FX7500 2.3.23 Release Notes

Release Notes for FX7500 V2.3.23

Released on 20/Apr/2017

Allow/disallow Guest User

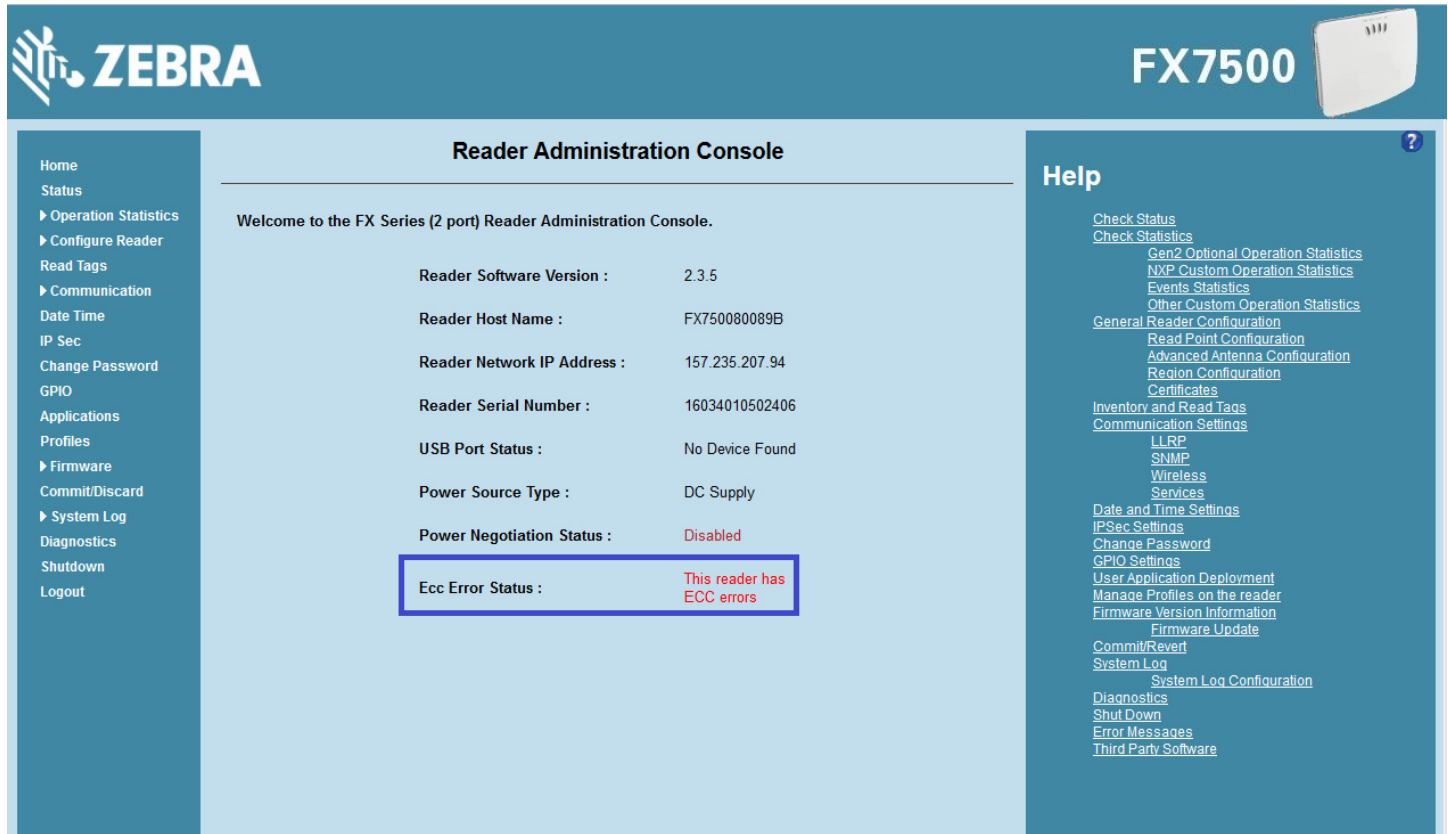
Option to control whether Guest User is allowed or not to access the reader.

- Allow Guest User** - Option to control whether Guest User is allowed or not to access the reader using the web console. When Checked (default) this option is enabled and Guest user is allowed to login to view the reader settings. Disabling this option prevents Guest user login to the reader's web console.
